TECHNICAL BULLETIN
JTB00355NAS1
13 JUN 2014

SECTION: 310-01E

Fuel Feed Pipe 'Rattle'

XF (X250)

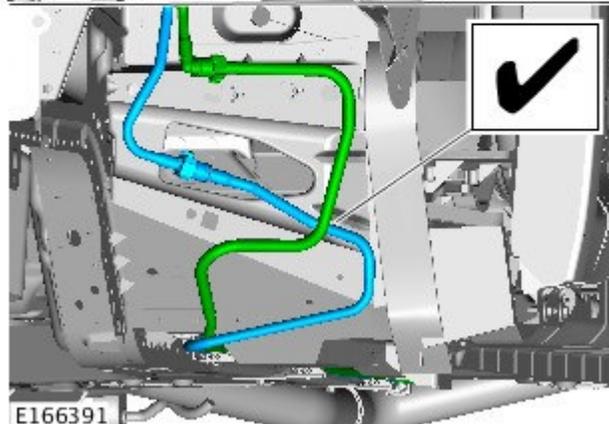
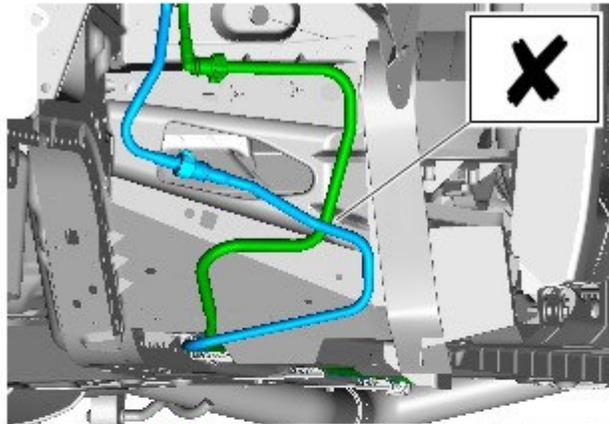
5. Re-route the hard plastic fuel line behind the braided fuel feed line.

- Make sure the hard plastic fuel line is flush to the body panel.

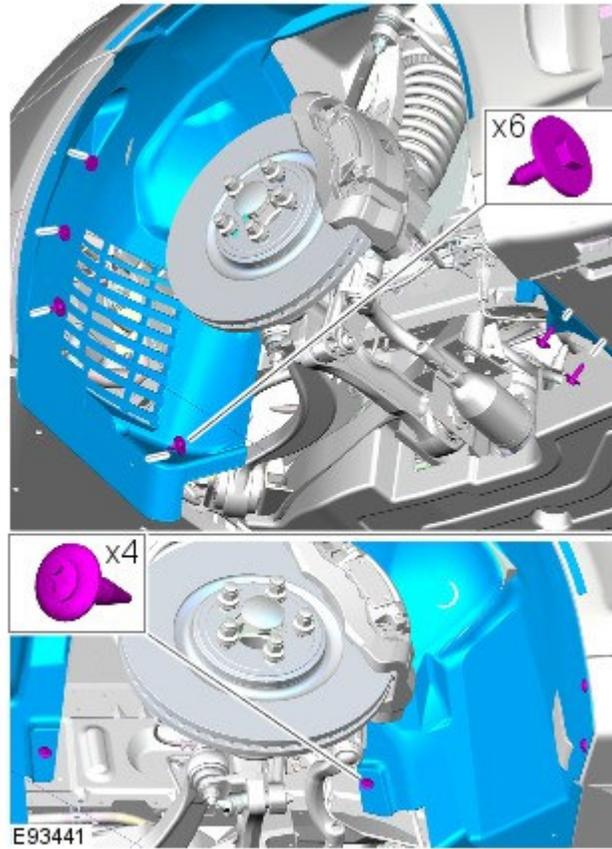
7. Install the clip to the fuel line and vehicle body in the position shown.
